NAVAL ASSESSMENT AND CONTROL
OF INSTALLATION POLLUTANTS
REVIEW WORKSHOP

NAS-JACKSONVILLE

VERIFICATION STUDY
CHARACTERIZATION STUDY

April 29, 1986

SITE NO. 18. RADIOACTIVE WASTE FILL AREA

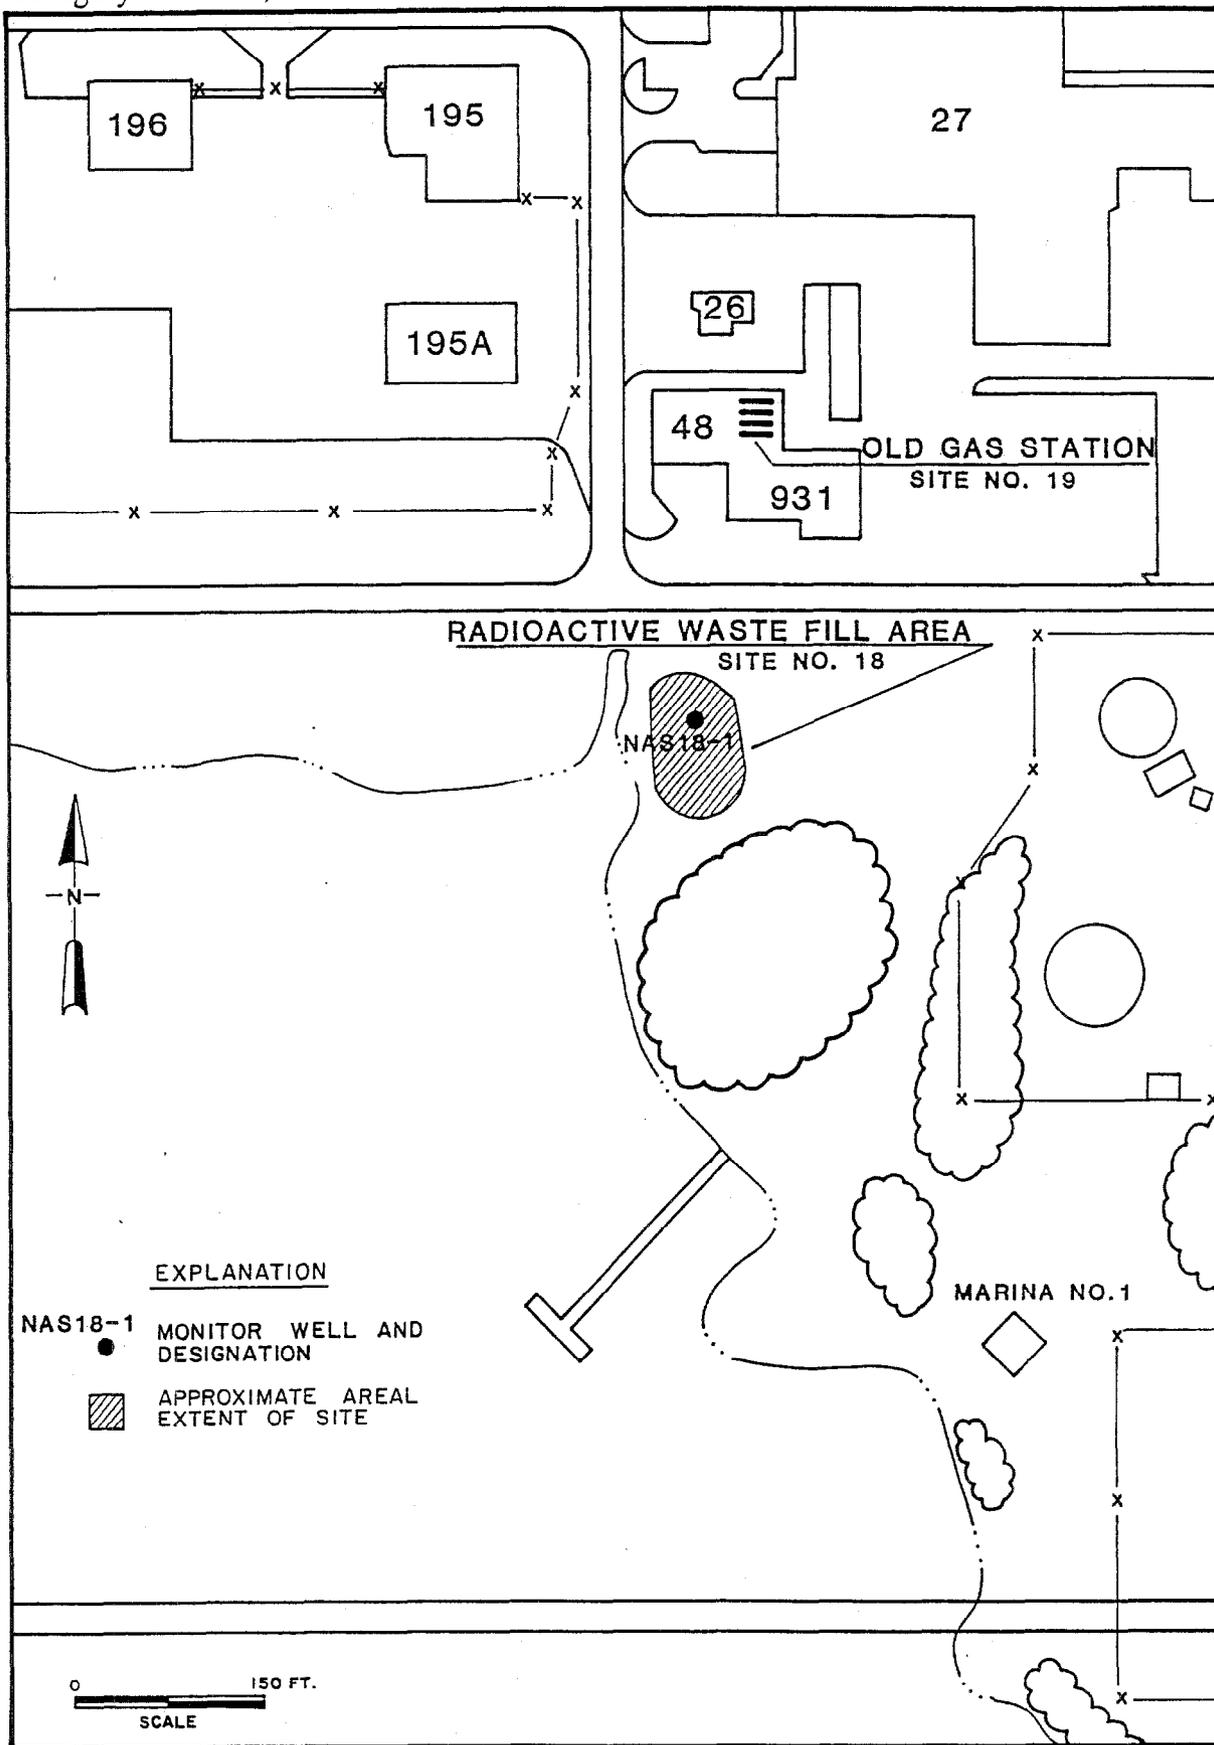
Drop it & Call DER

SITE NO. 19. OLD GAS STATION

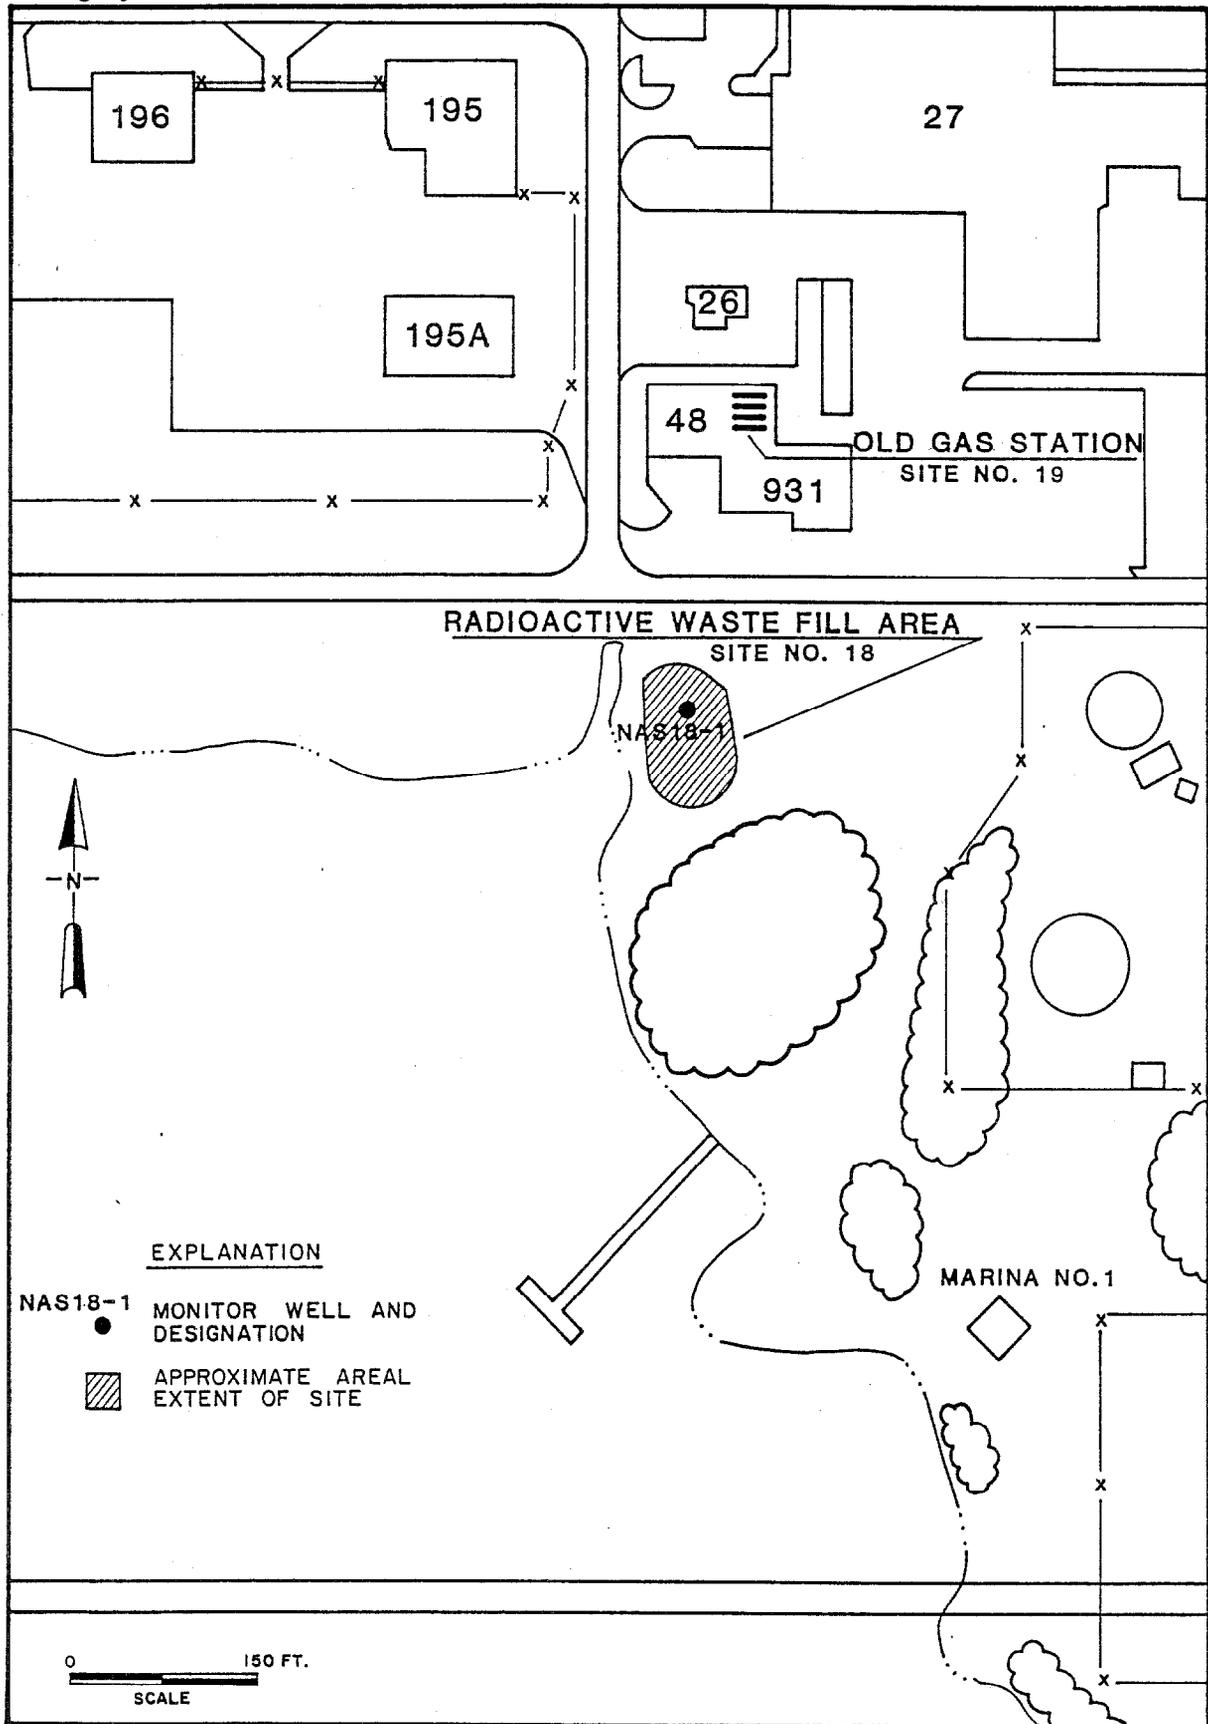
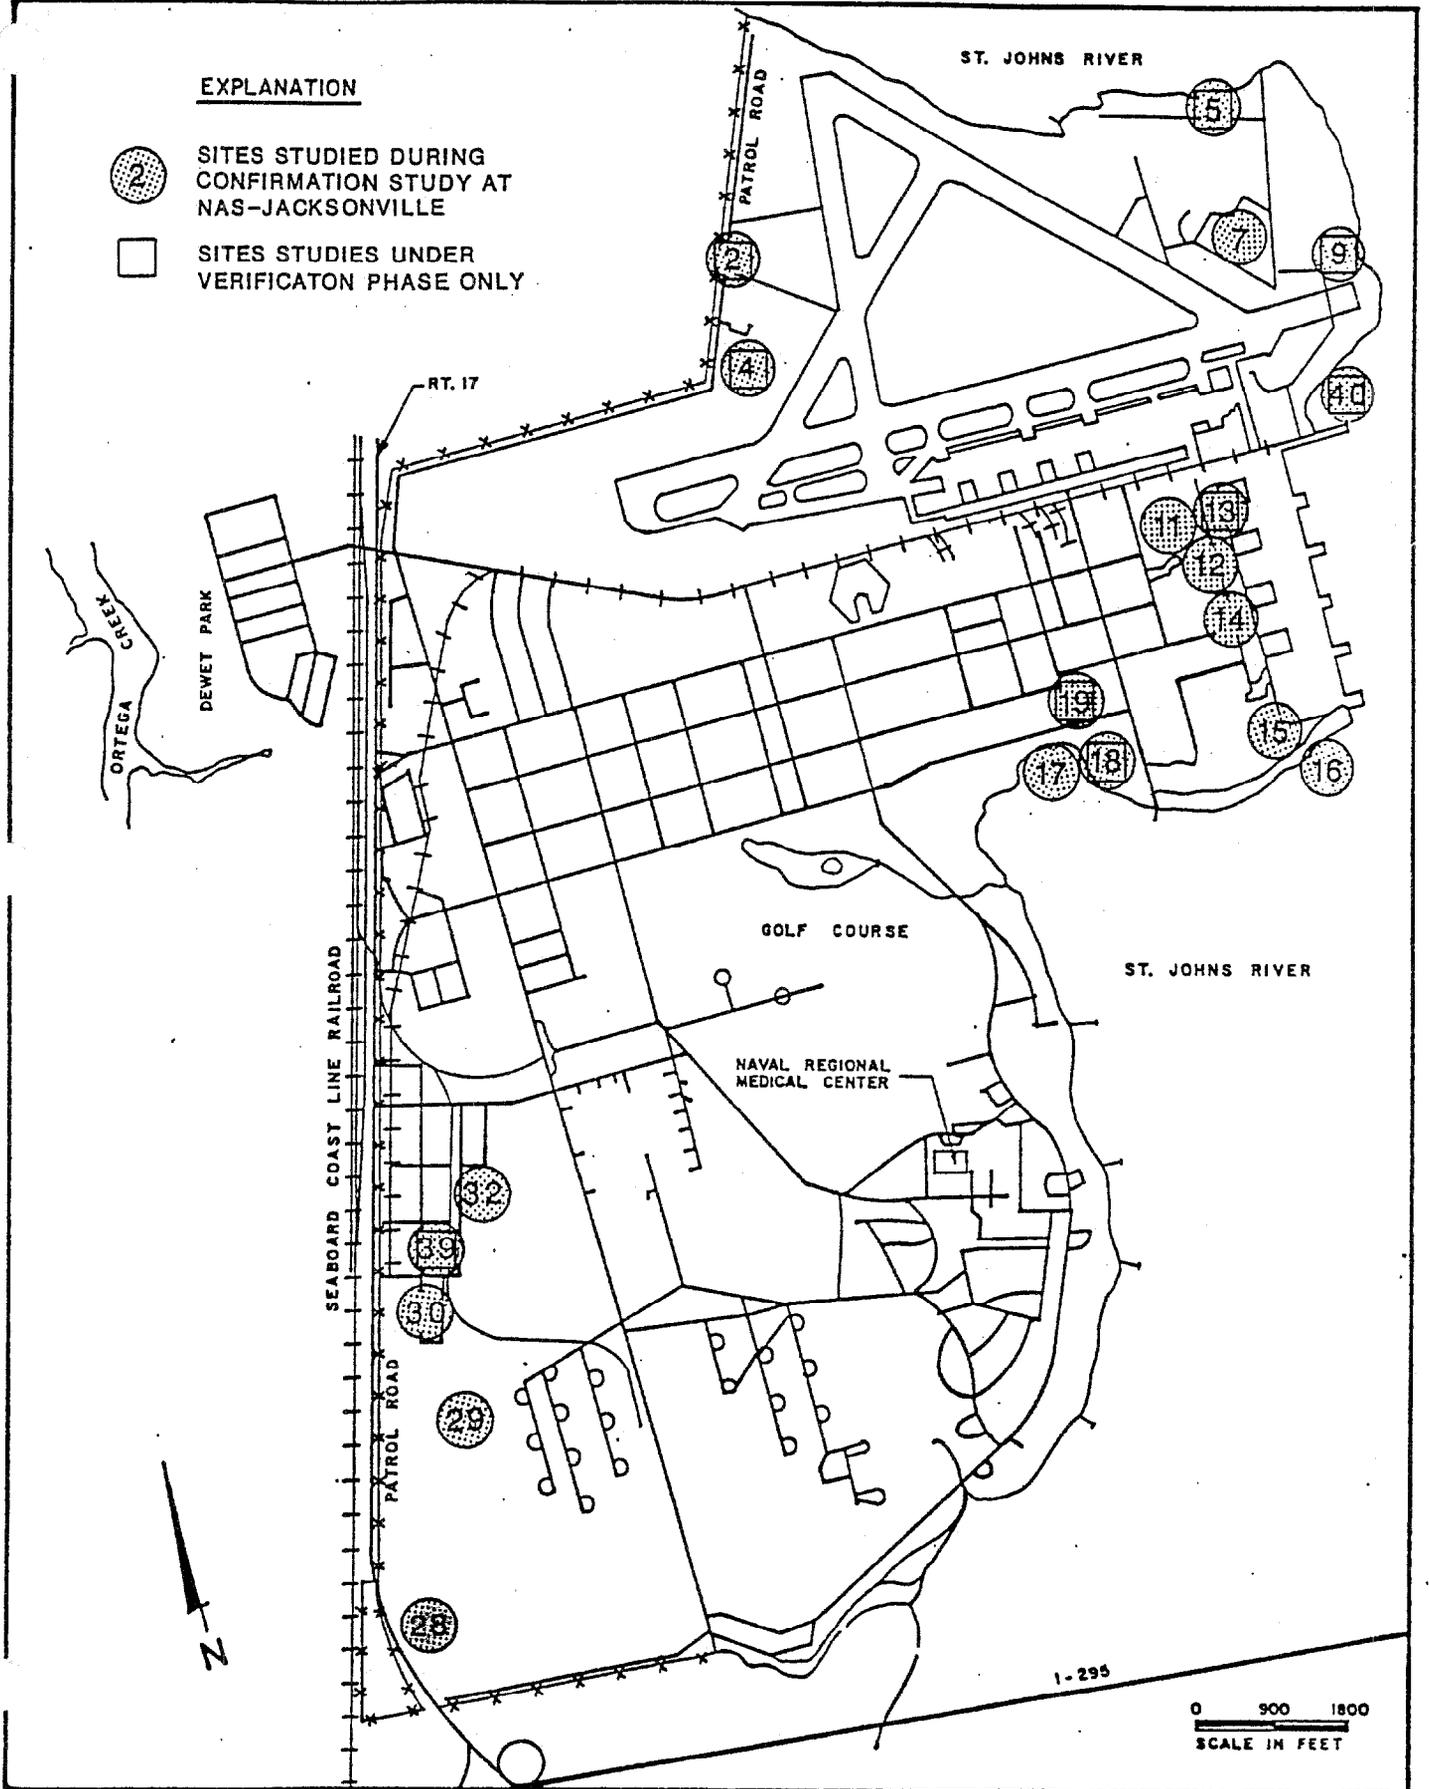
① Cathy wants a 601 + 602 completed from well # WAS 18.1

② Wayne doubts if they would be of value.

③ James agrees with Wayne

④ Mr Crane and Mr Fitzgibbon say to handle under ^{FAC} 17-61

SITE NO. 28. FIRE PIT

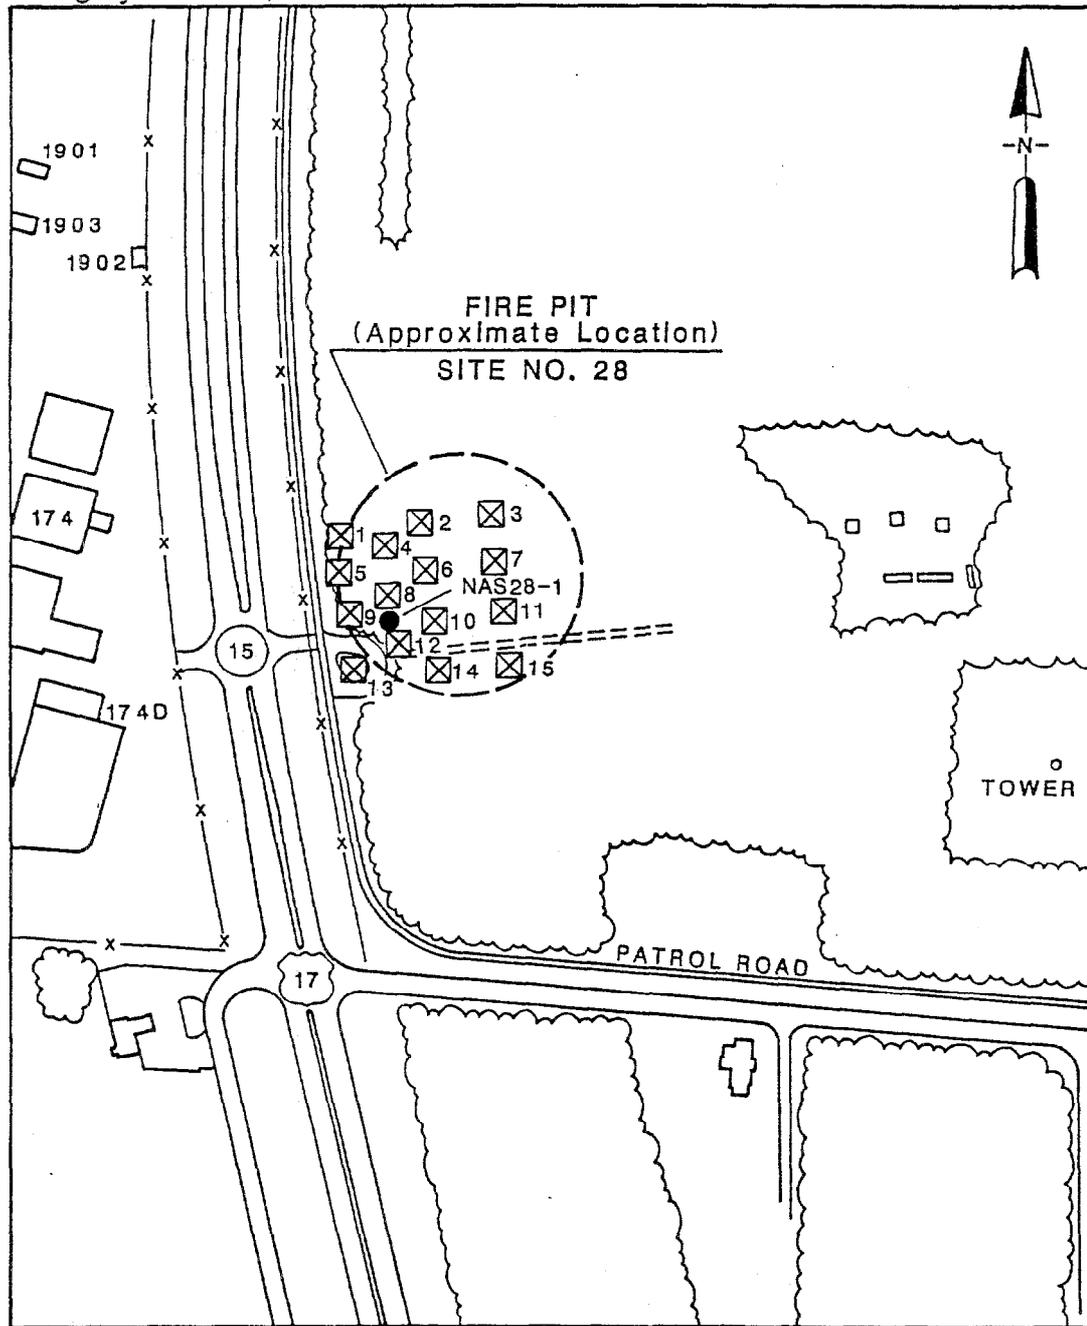
Mr. Crane agrees to drop it 11-29-84

ORGANIC DISPOSAL AREA
SITE NO. 29

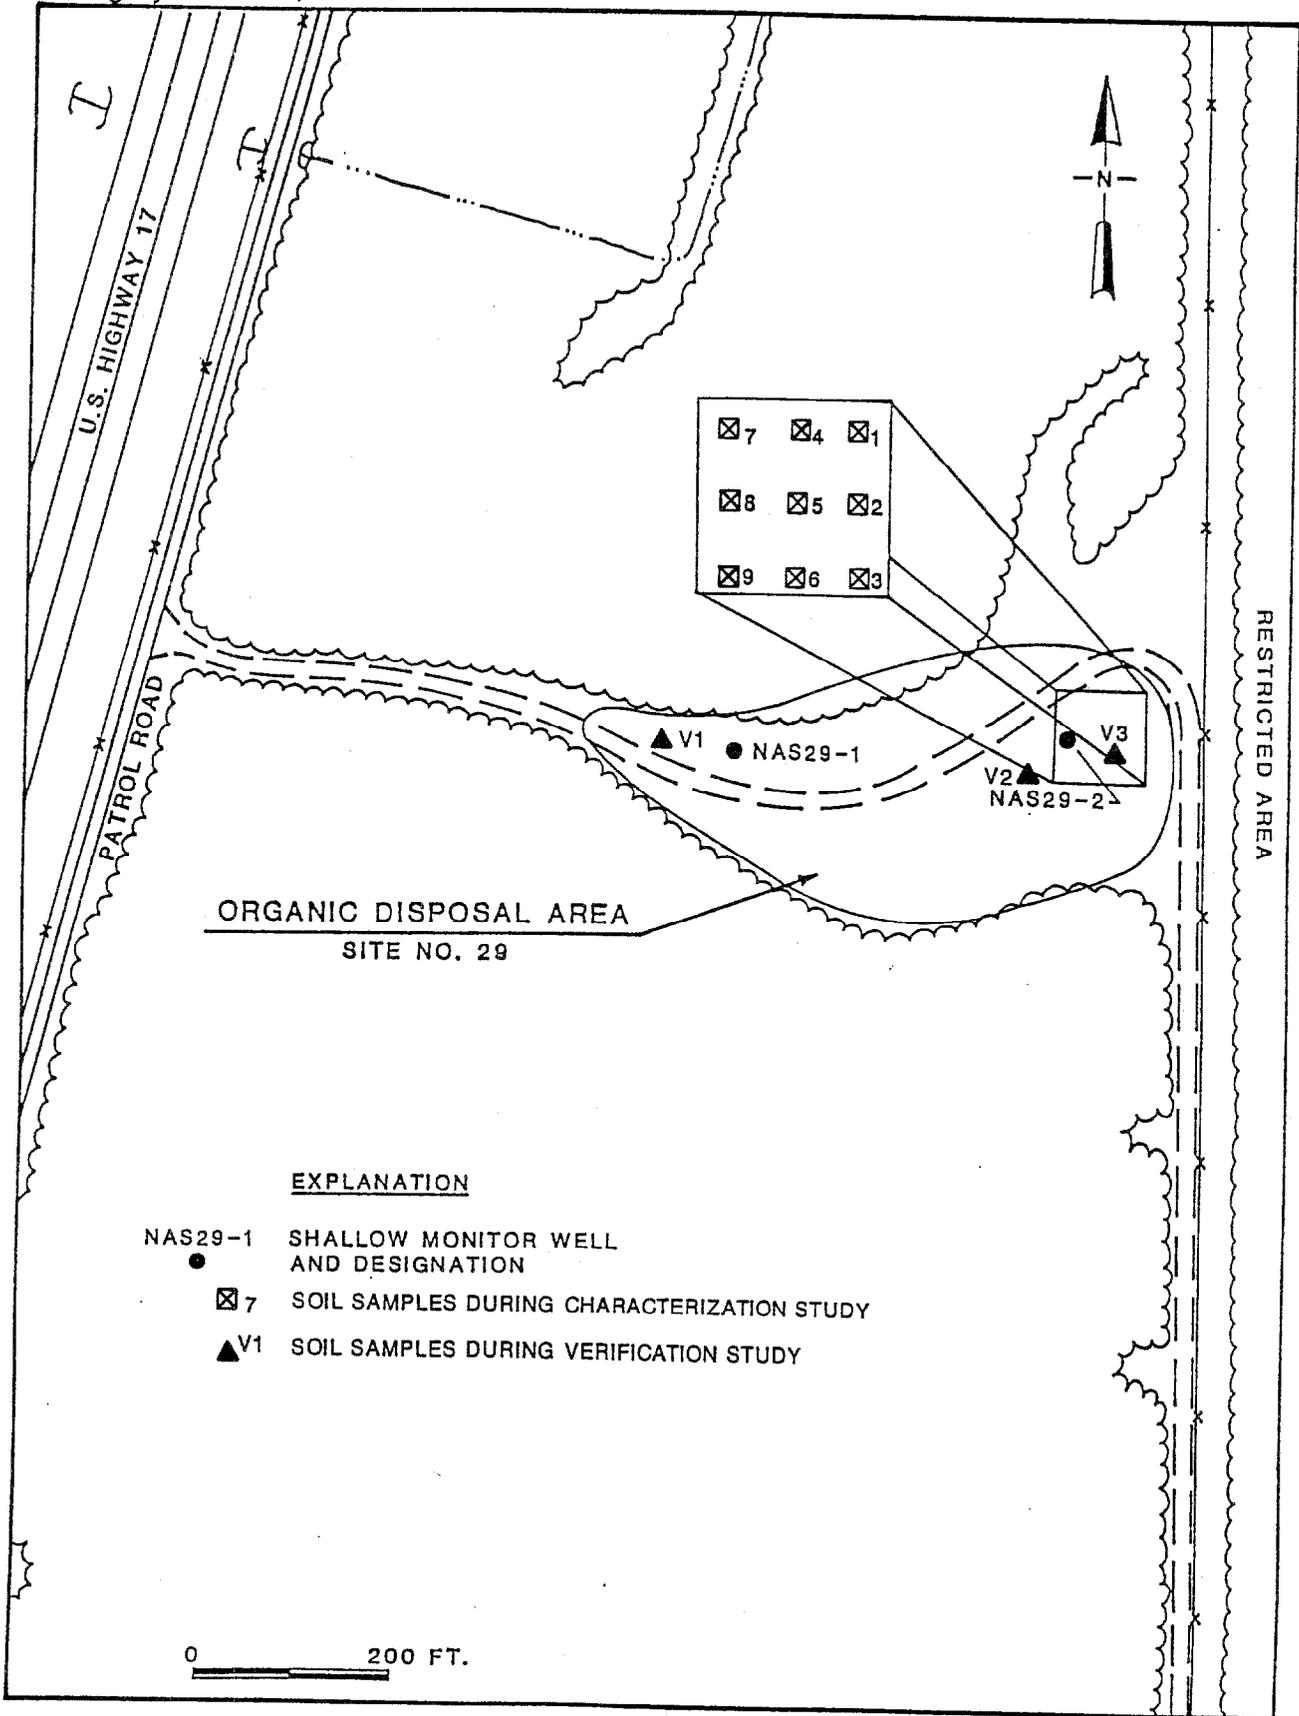
Drop it.
